NATIONAL WEATHER SERVICE

Engineering Handbook

MODIFICATION INDEX - AMOS III-70/73

AUTOMATIC OBSERVING EQUIPMENT MODIFICATION No.1
(For Electronics Technicians)

AMDS Modification #9 -- Figure 5.

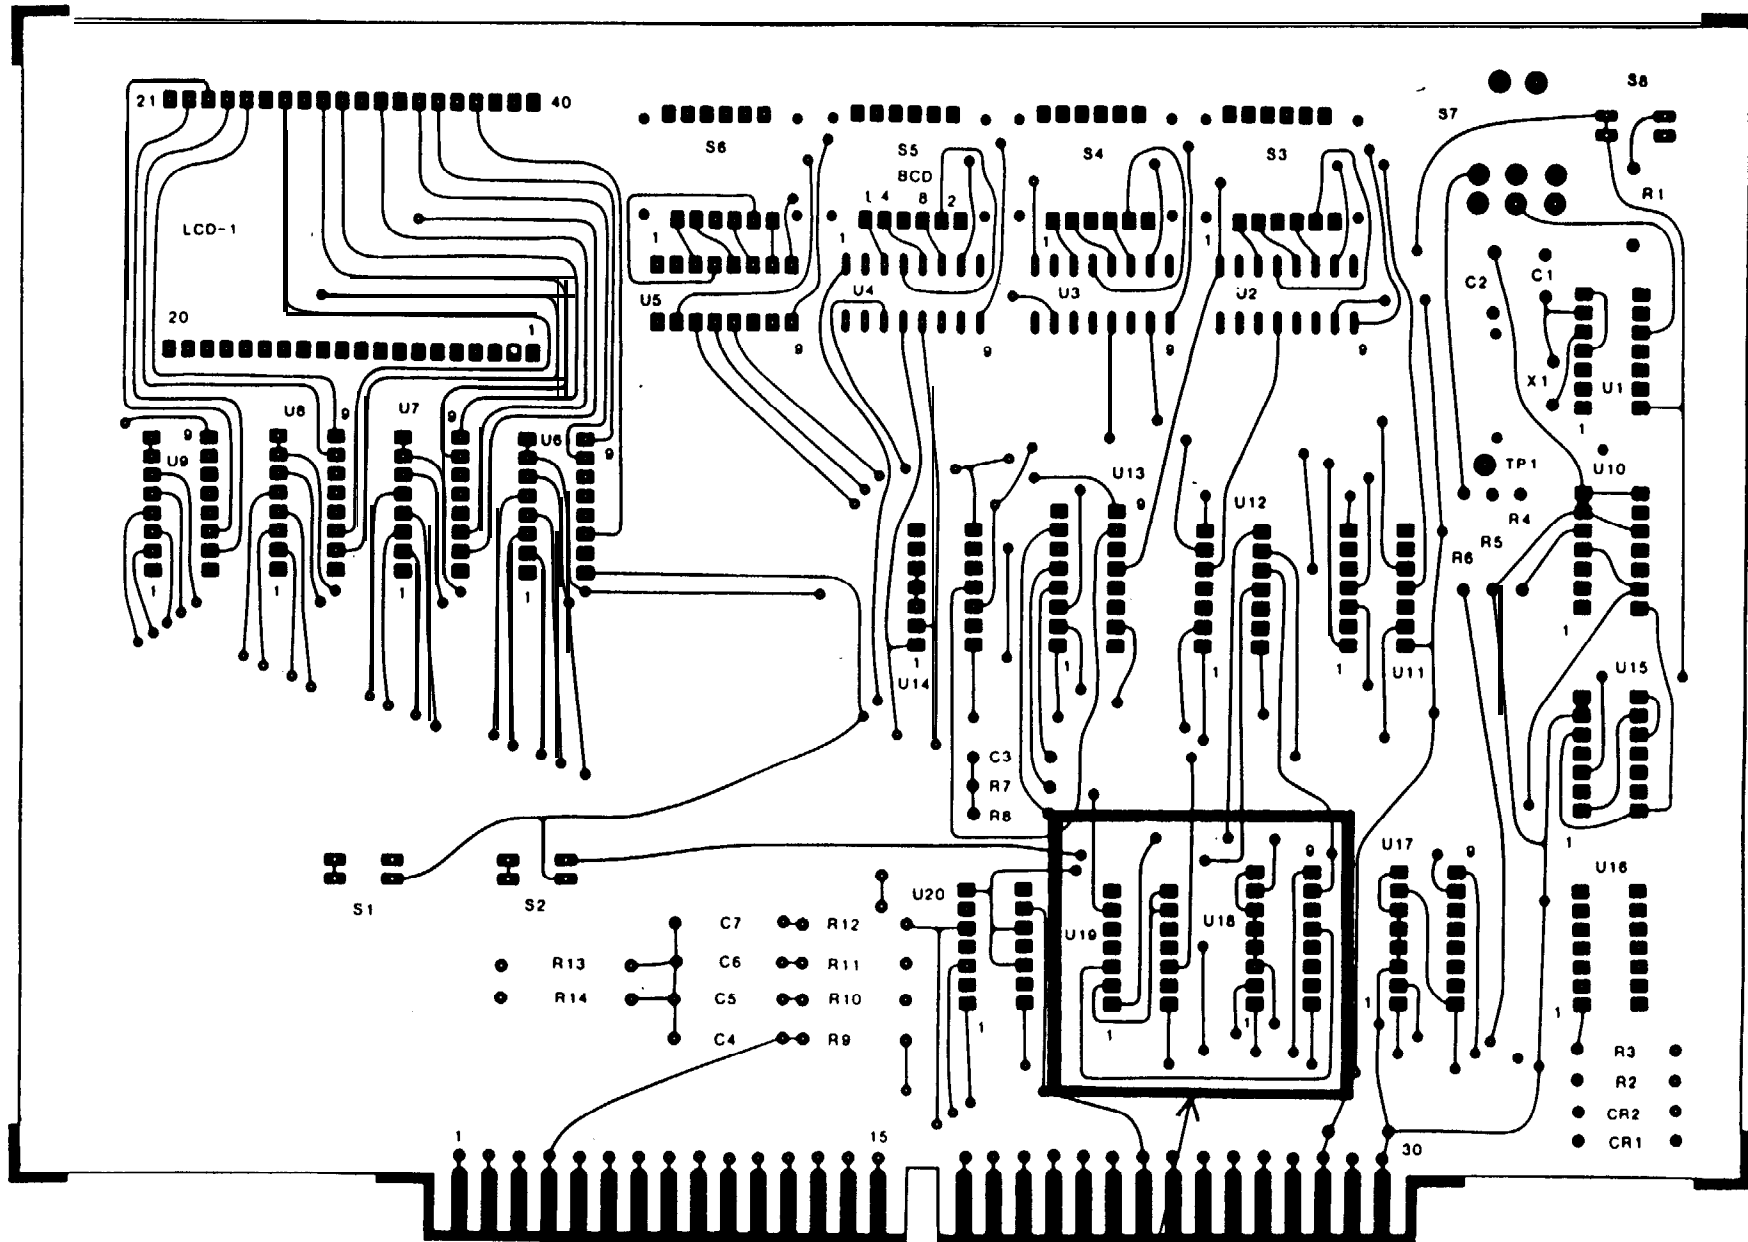
7. Using attached Figures 5, 6, and 7; locate the land running between U18-12 and U19-3. Remove a small portion of the land identified in Figure 6. This will disconnect the "40 SEC TIMER" output from the "WINDOW CONTROL".

Enlargement of new Clock Module, circuit side

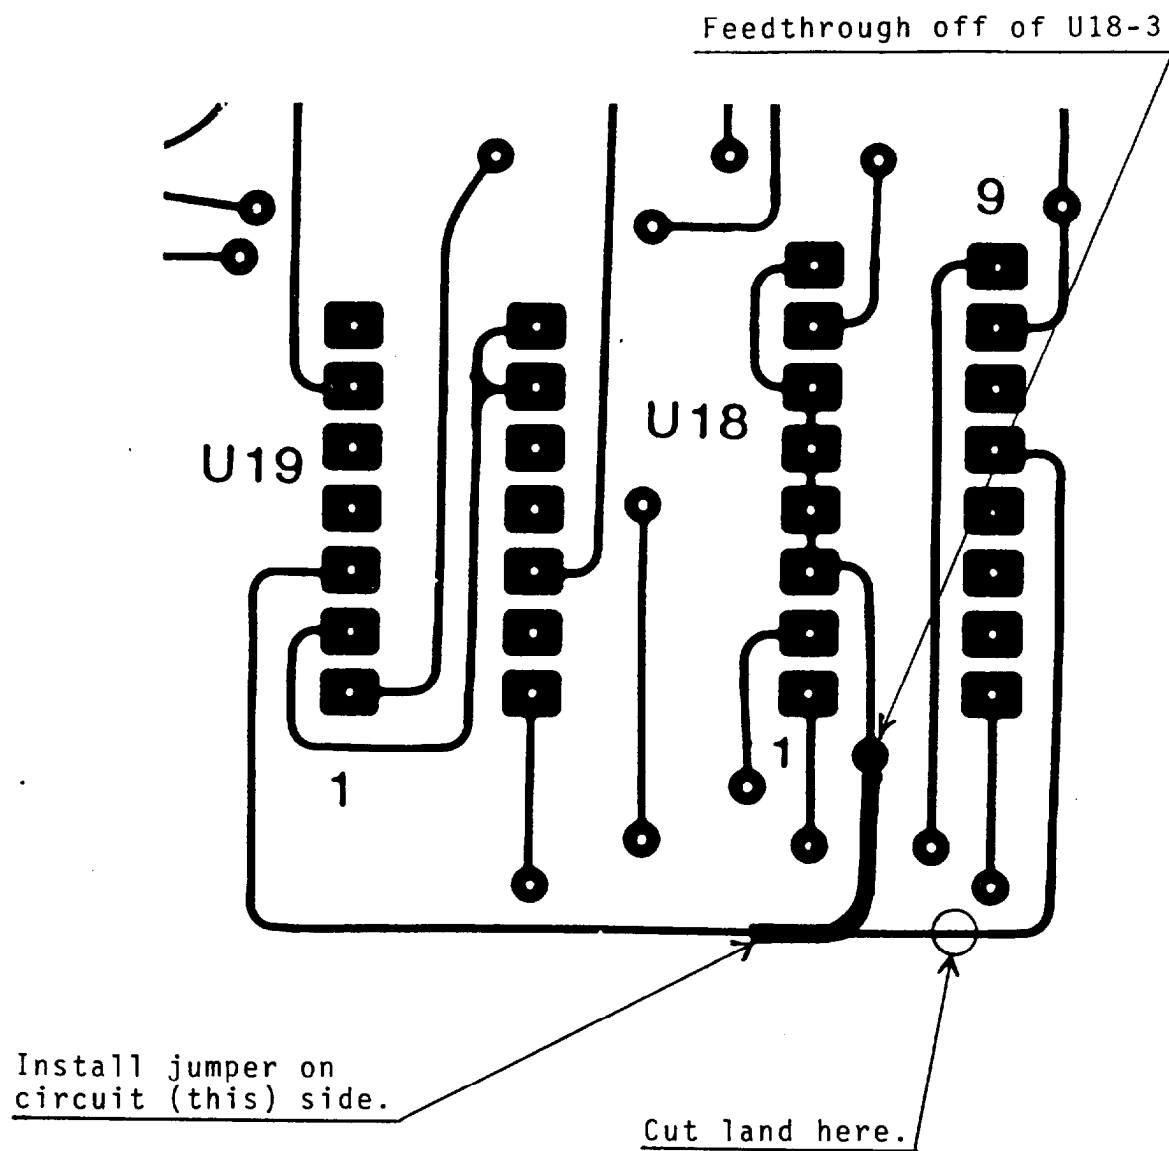
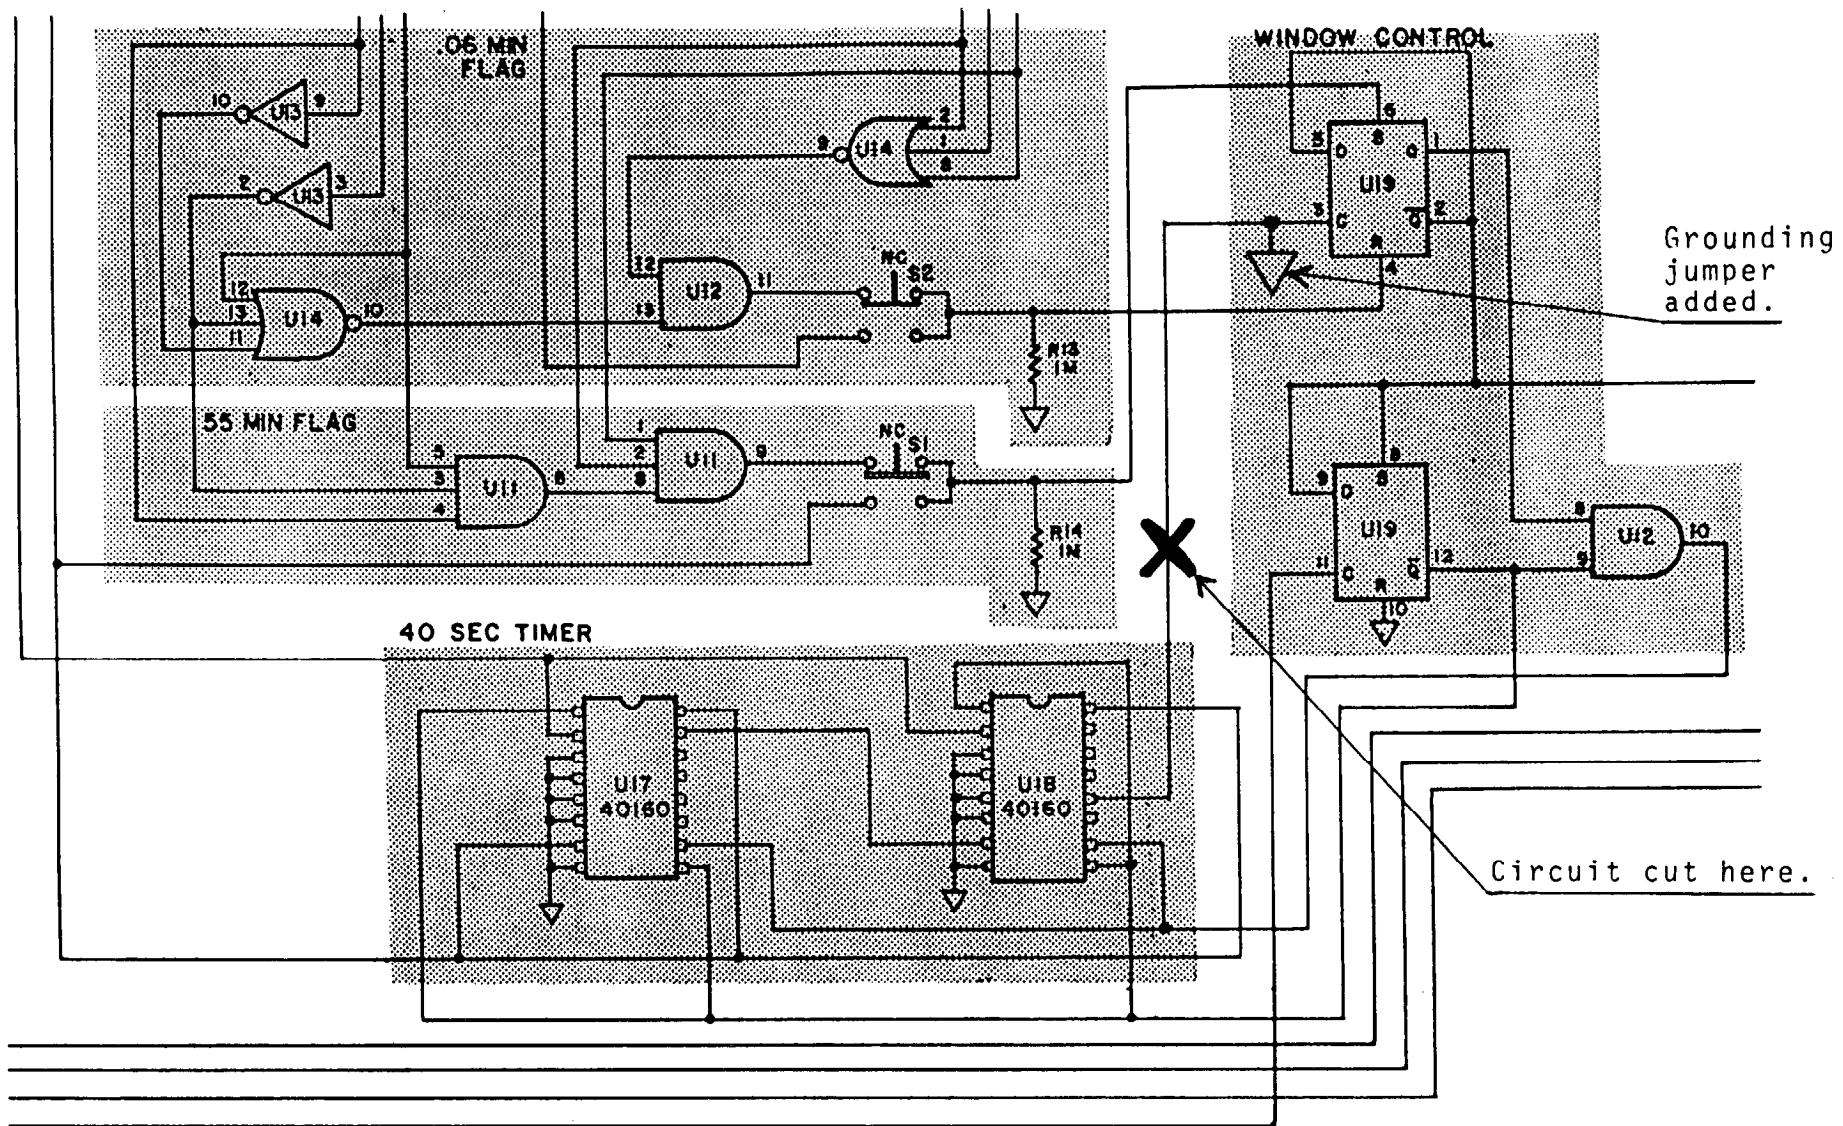
8. Using attached Figures 6 and 7; locate the feedthrough connected to U18-3 (ground). Install a wire jumper on the circuit (non-component) side of the board between the feedthrough and the cut land as shown in Figure 6. This grounds the "WINDOW CONTROL" flip-flop clock input.

Insulated jumper to be installed
on component (this) side.

See Figure 6 for enlargement.
